Subject: Woodinville Annex Building

Reference: 1997 Uniform Code for the Abatement of Dangerous Buildings Dear Dean:

Subject: Woodinville Annex Seismic Retrofit

SHAPTON & PARTNERS, INC. CONSULTING ENGINEERS	WOODINVILLE SCHOOL 13203 NE 175TH STREET SEISMIC EVALUATION	DATE: 12/03/01
FILE NO: 03502		DETAIL NO. SK-1

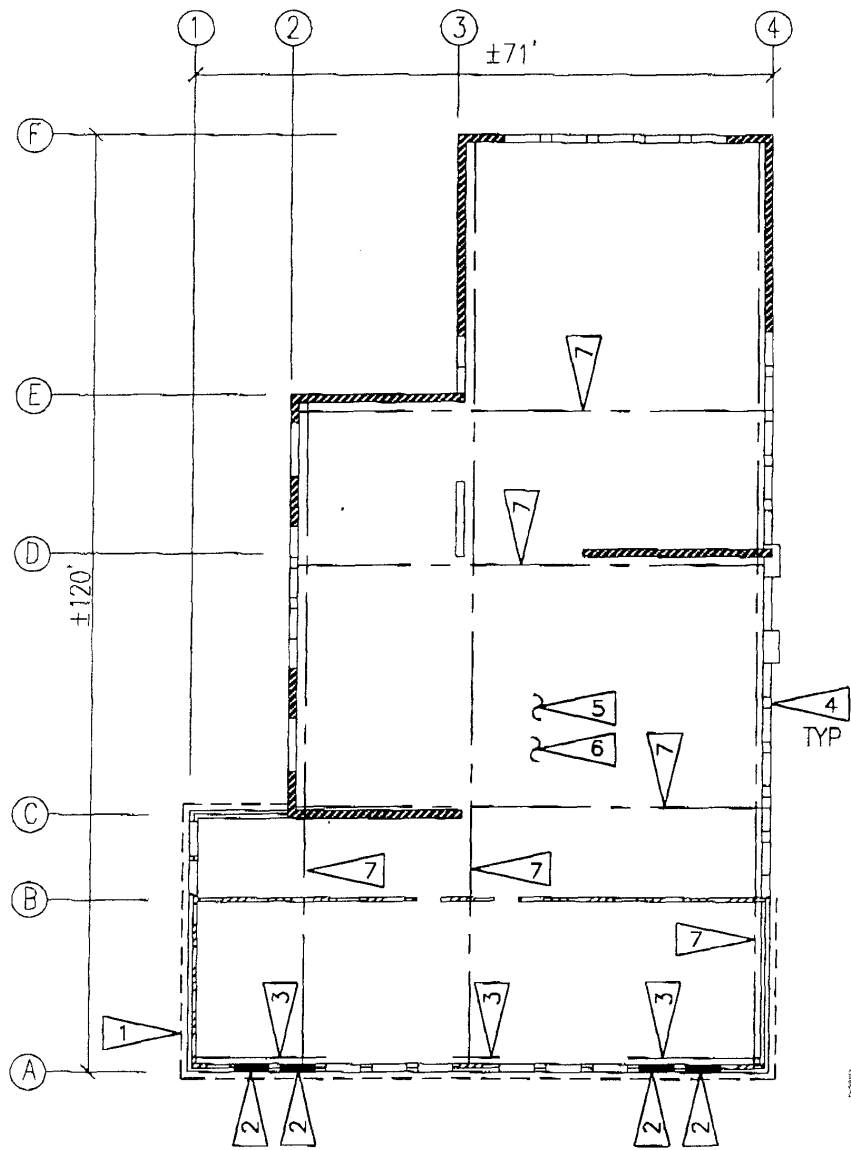
As we have discussed on numerous occasions, the primary life-safety concern with the annex building is the potential for the exterior walls to separate from the floor/roof construction during an earthquake. Separation, in addition to the hazard of falling debris to those outside the building, would cause the structure to collapse. The as-built URM wall anchorages are significantly deficient. Further, upon your selective demolition work undertaken to verify assumptions made during my evaluation, we now have a sound basis question the integrity of the masonry veneer anchorages. Tie spacing observed exceeded that of the NEPRP Recommended Provisions by approximately 100% and failed when subjected to a simple pull test,

You have asked that I evaluate the above relative to .1997 Uniform Code for the Abatement of Dangerous Buildings. It is my opinion that these structural deficiencies fall under paragraph 14 of Section 302 and by definition this structure should be classified as a Dangerous Building.

1. Anchor masonry veneer to existing stud wall construction.
2. Infill existing window opening with new masonry veneer to match existing.
3. Sheath wall and nail per P1-3 (10d @ 3") requirements. Provide hold downs at chords each

1. floor and anchor to foundation.
4. Anchor existing unreinforced masonry walls to roof/floor diaphragms. Assume 3/4" through bolts @ 32", Reference Hilti Figure 2 (attached), This detail occurs at the roof diaphragm, 2<sup>nd</sup> floor ceiling diaphragm, 1" floor ceiling diaphragm and at the basement ceiling diaphragm.

5. Remove existing roof structure and replace with new 1/2" plywood over 2x6 @ 24" construction. Block diaphragm, nail with 10d @ 4" and provide continuous ties between diaphragm chords.

6. Provide a new 1/4" plywood diaphragm at the 2<sup>nd</sup> floor ceiling, 1" floor ceiling, and basement ceiling Levels. Block diaphragm, nail with 10d @ 4" and provide continuous ties between diaphragm chords.

7. Provide new diaphragm collector at roof, 2<sup>nd</sup> floor ceiling, 1<sup>st</sup> floor ceiling, and basement ceiling. Assume L4x4x3/8.
